ADDENDUM NUMBER THREE

DARLA MOORE SCHOOL OF BUSINESS CONSTRUCTION – BP-3
ENCLOSURE/SITE/MEFP/INTERIOR
UNIVERSITY OF SOUTH CAROLINA
STATE PROJECT NUMBER H27-6069-AC-3

DATE OF ISSUE: June 22, 2012

EXTENT OF PAVEMENT REMOVAL/REPAIR FOR STEAM/CONDENSATE LINE WORK REVISION
REF. DWG # C1600_bp3
SHEET TITLE :

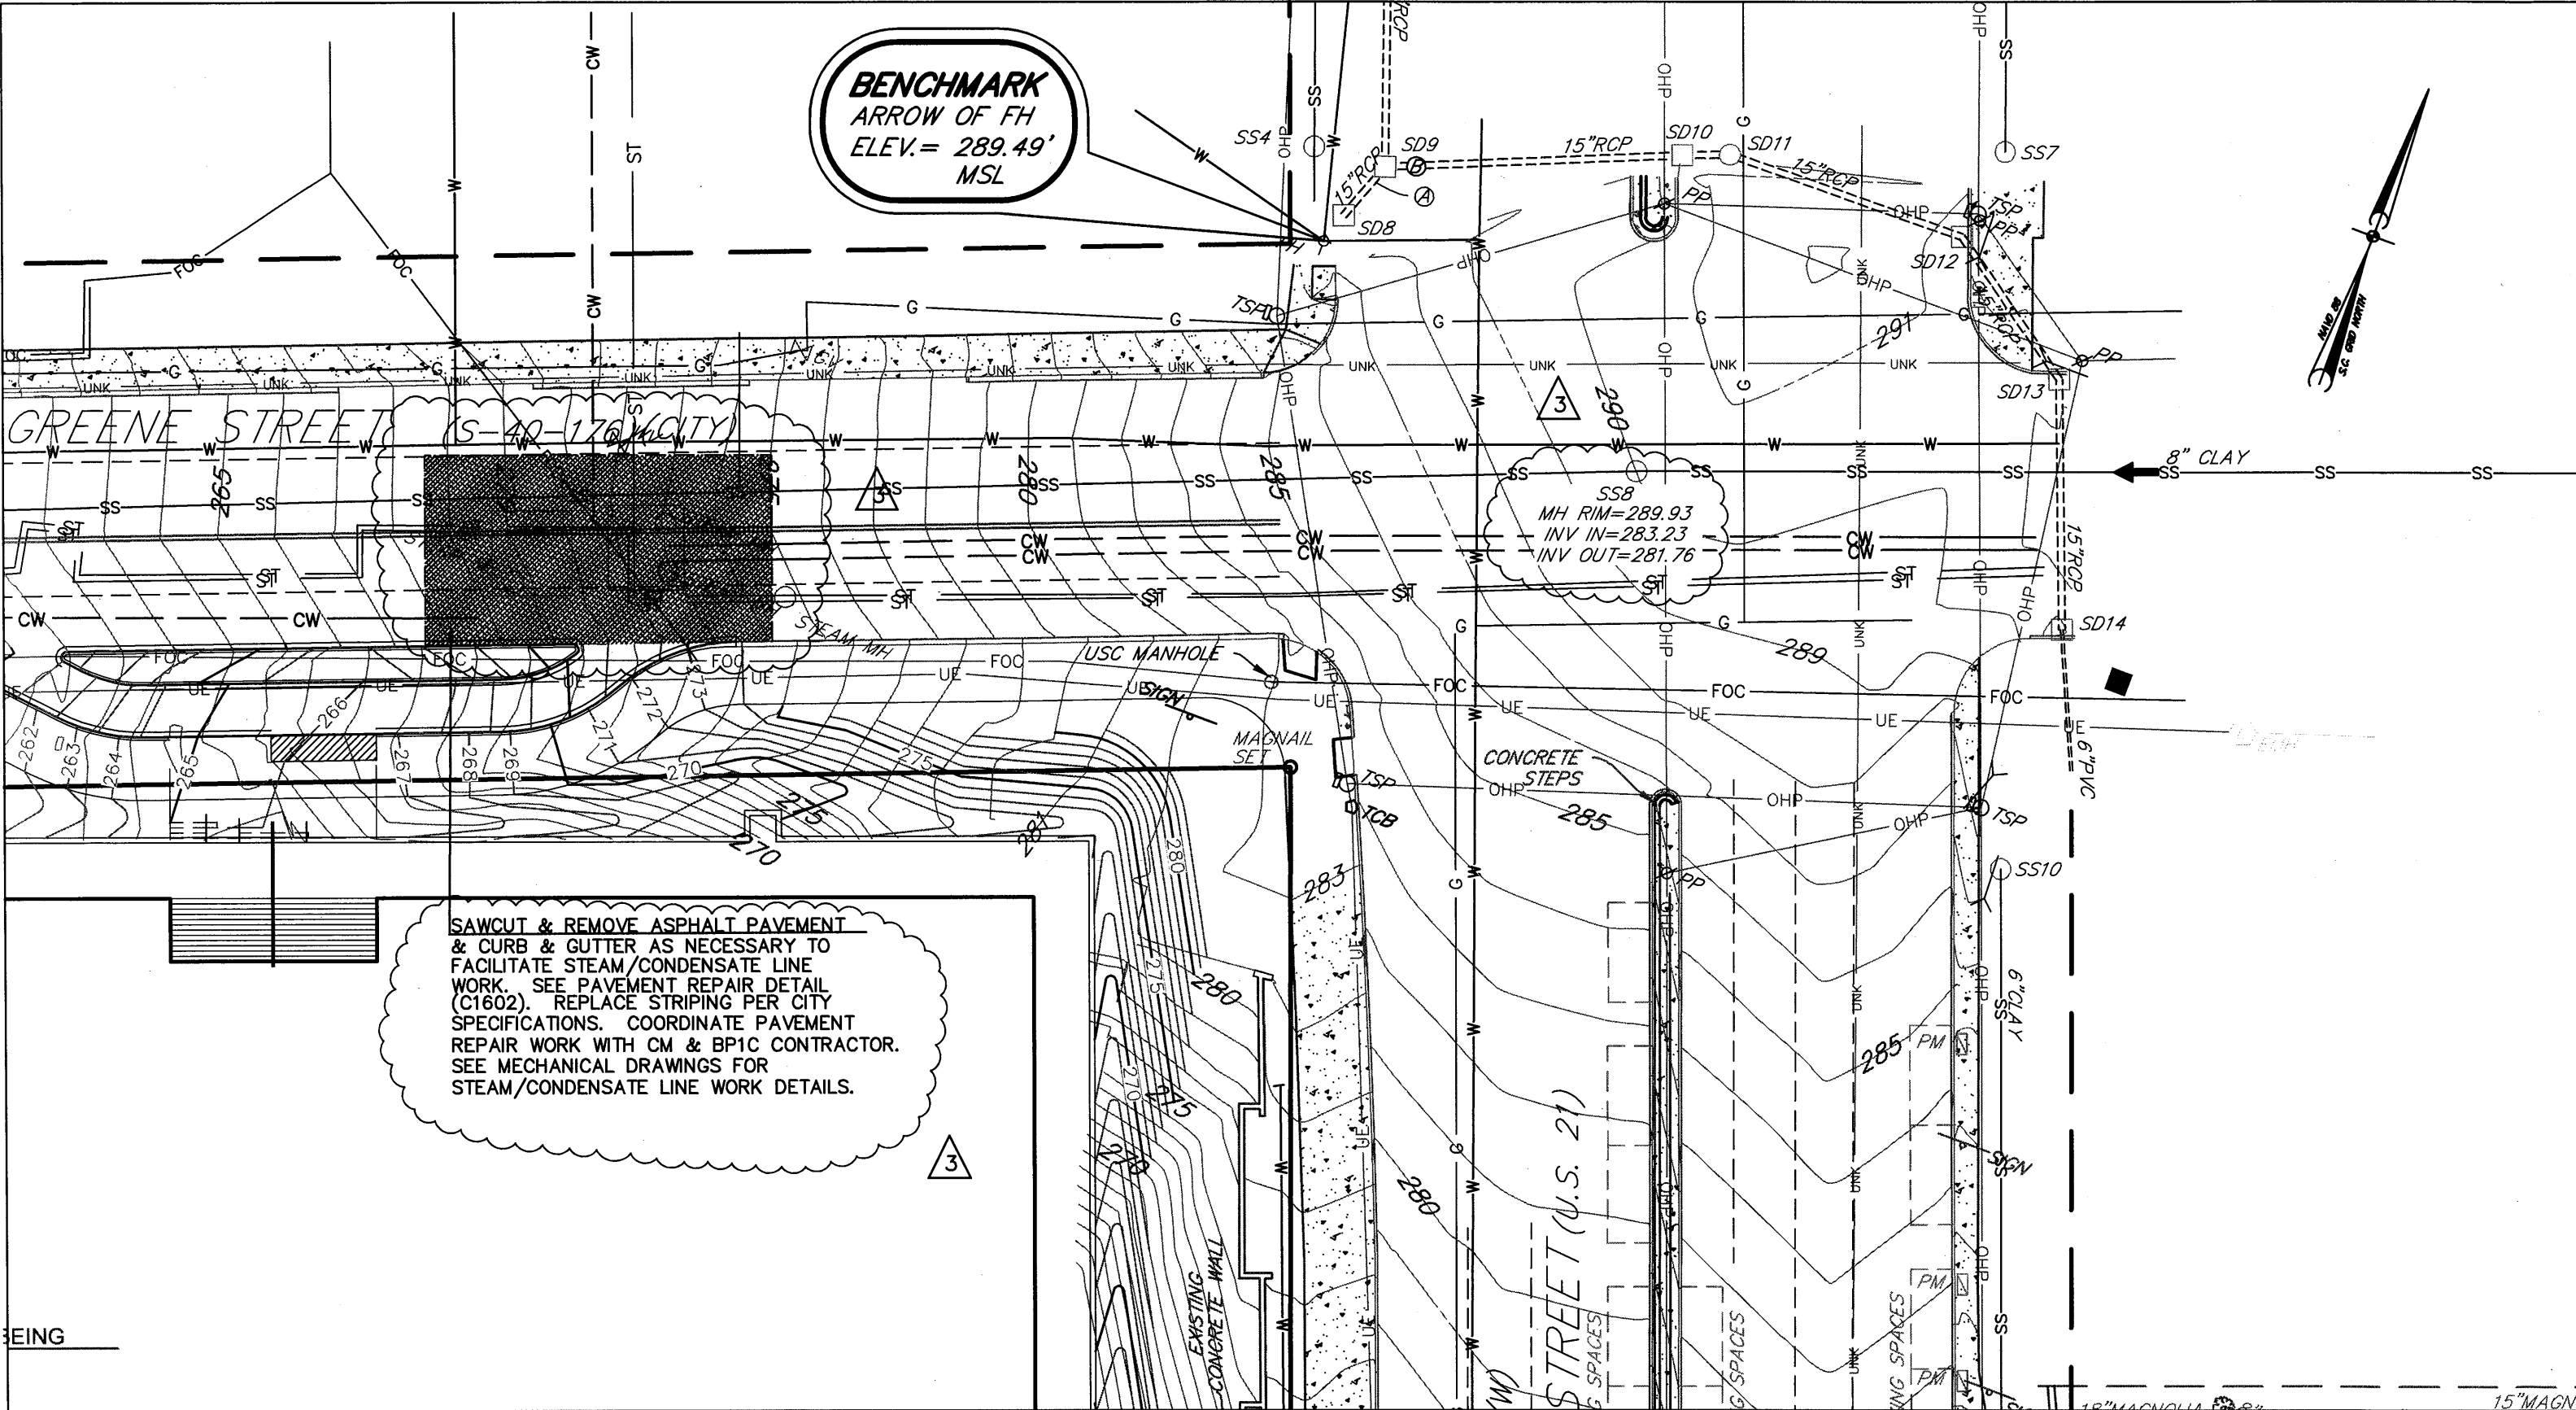
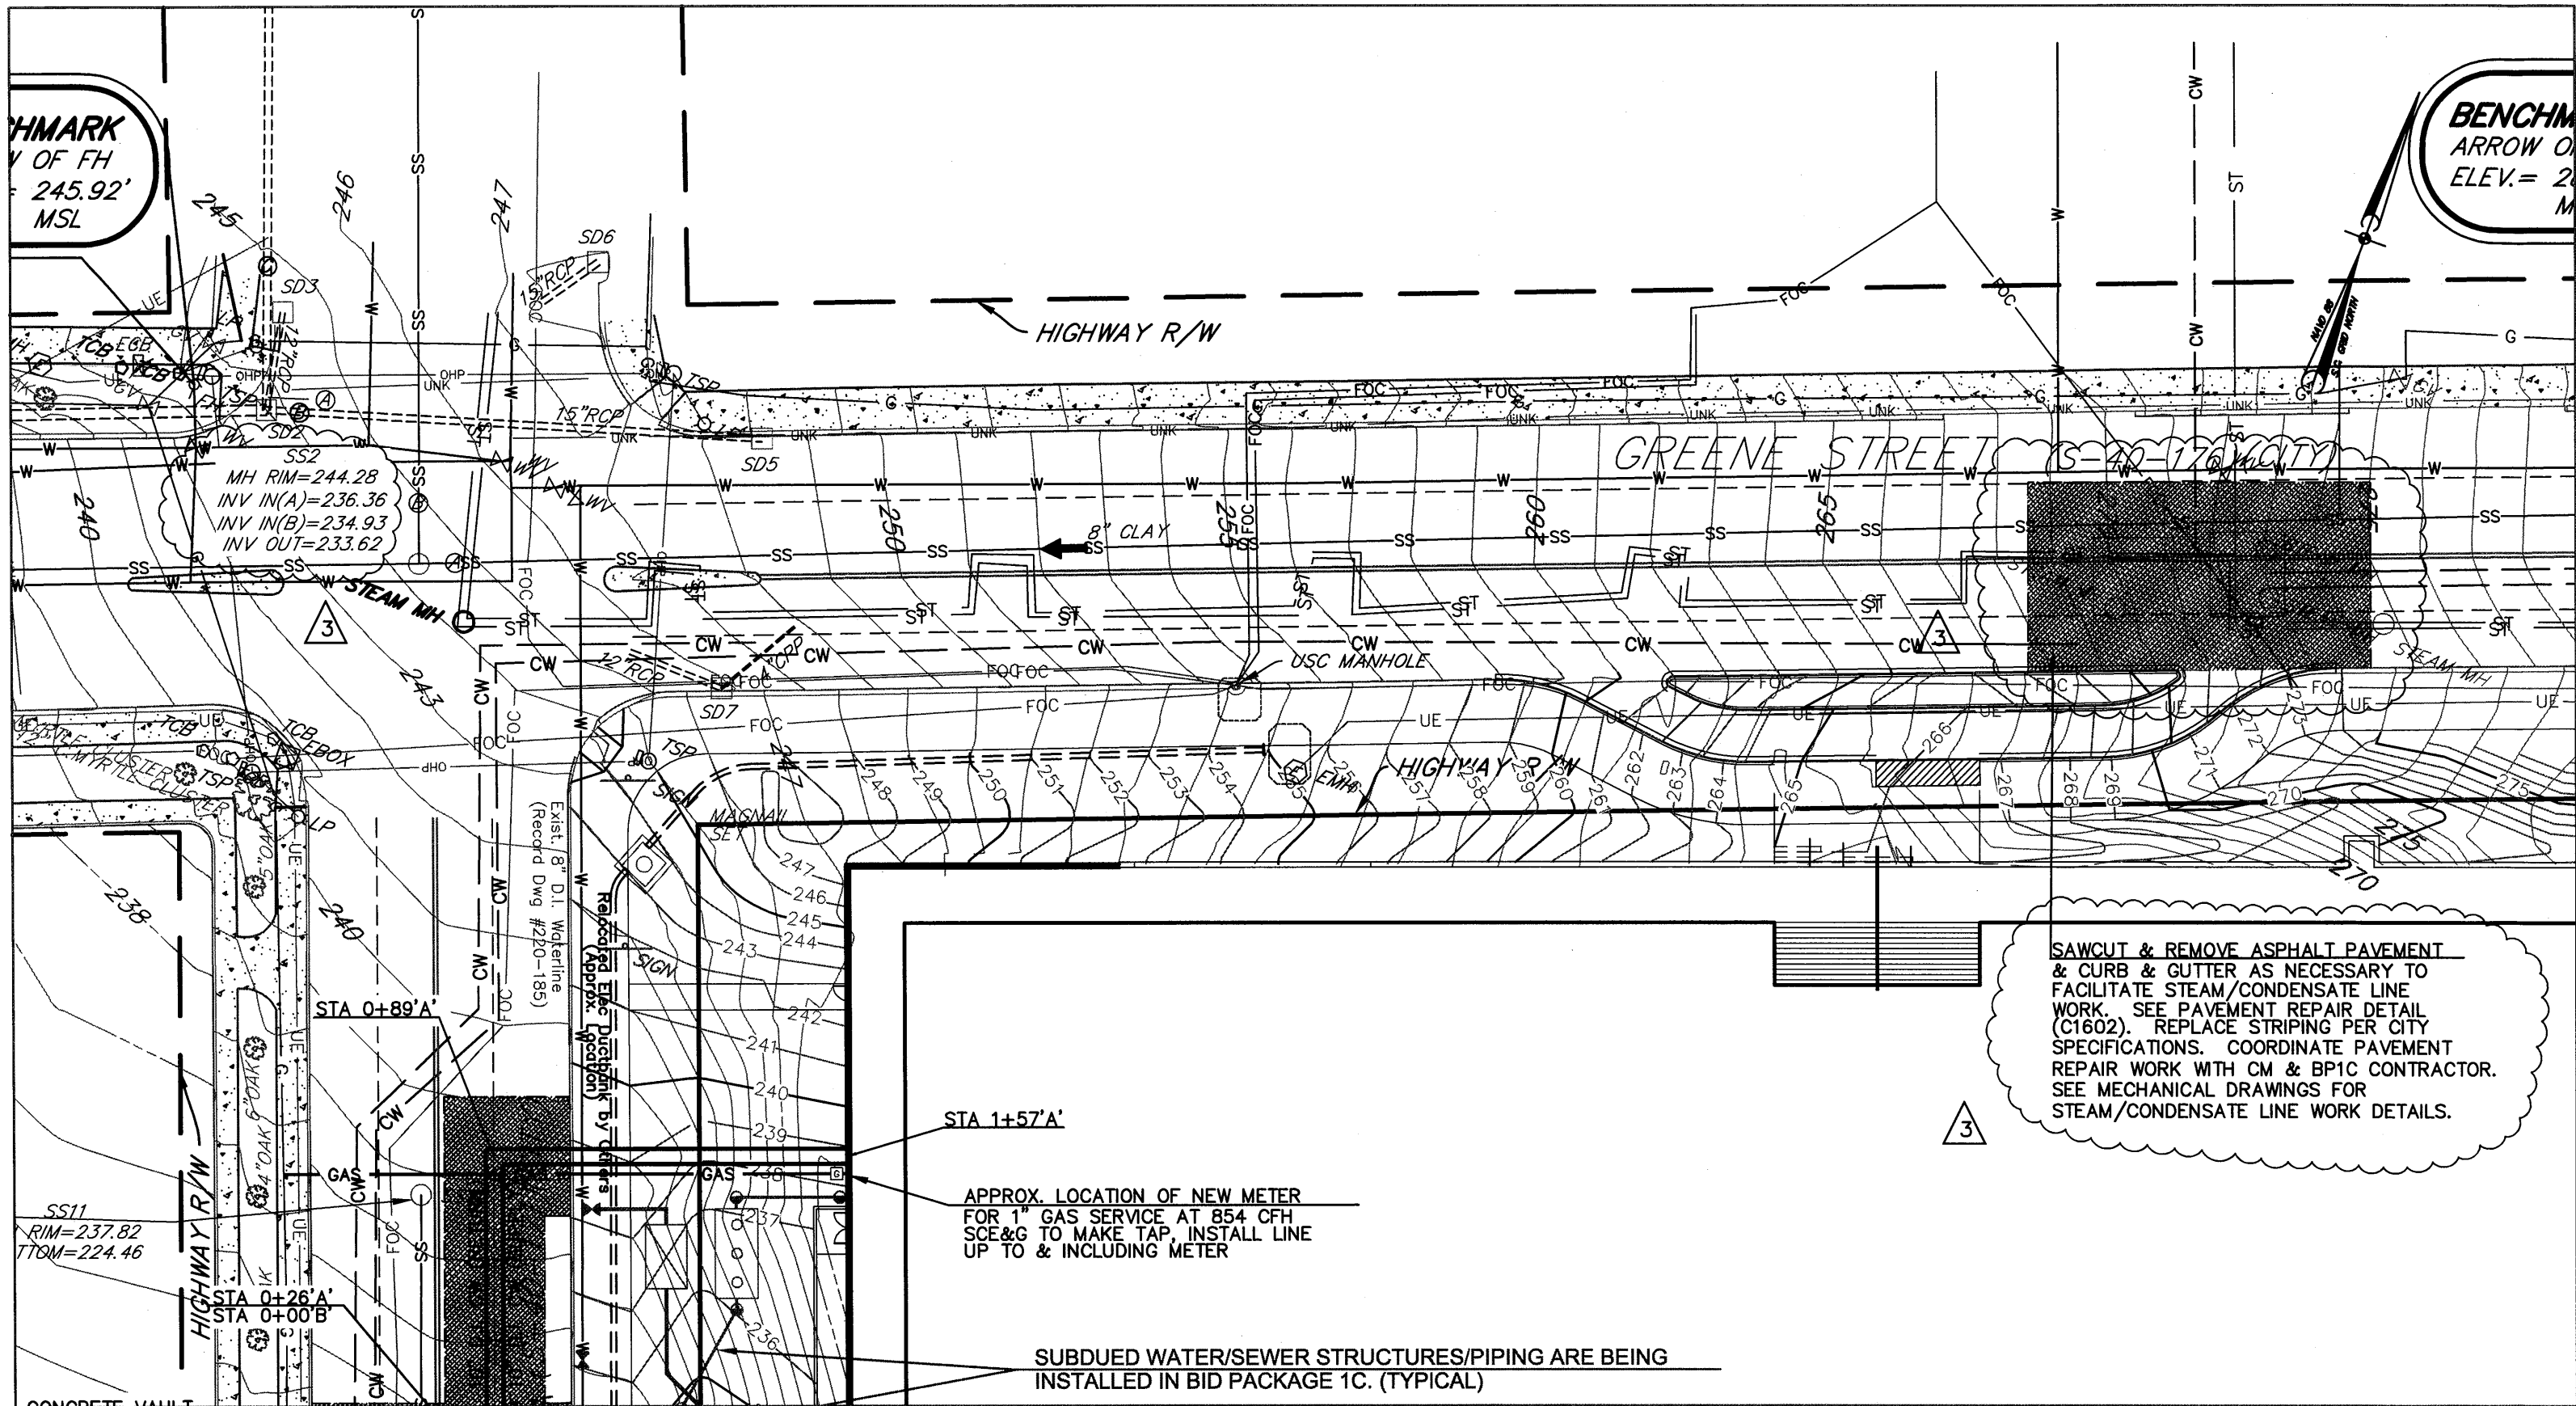
1. ADDENDUM THREE GENERIC SCHEDULE RECAP
2. C-SK-003: CONCRETE CHILLED WATER VAULT DETAIL REVISION
3. C-SK-004: CONCRETE CHILLED WATER VAULT DETAIL REVISION
4. C-SK-005: CONCRETE CHILLED WATER VAULT DETAIL REVISION
5. C-SK-006: CONCRETE CHILLED WATER VAULT DETAIL REVISION
6. C-SK-007: EXTENT OF PAVEMENT REMOVAL/REPAIR FOR STEAM/CONDENSATE LINE WORK REVISION
7. C-SK-008: EXTENT OF PAVEMENT REMOVAL/REPAIR FOR STEAM/CONDENSATE LINE WORK REVISION
8. C-SK-009: RAINWATER HARVESTING SYSTEM LAYOUT REVISION
9. C-SK-010: ROOF DRAINAGE COLLECTOR LINE C PROFILE REVISION
10. C-SK-011: LOCATION OF RAINWATER HARVESTING SYSTEM TANK & FIRE WATER TANK REVISION
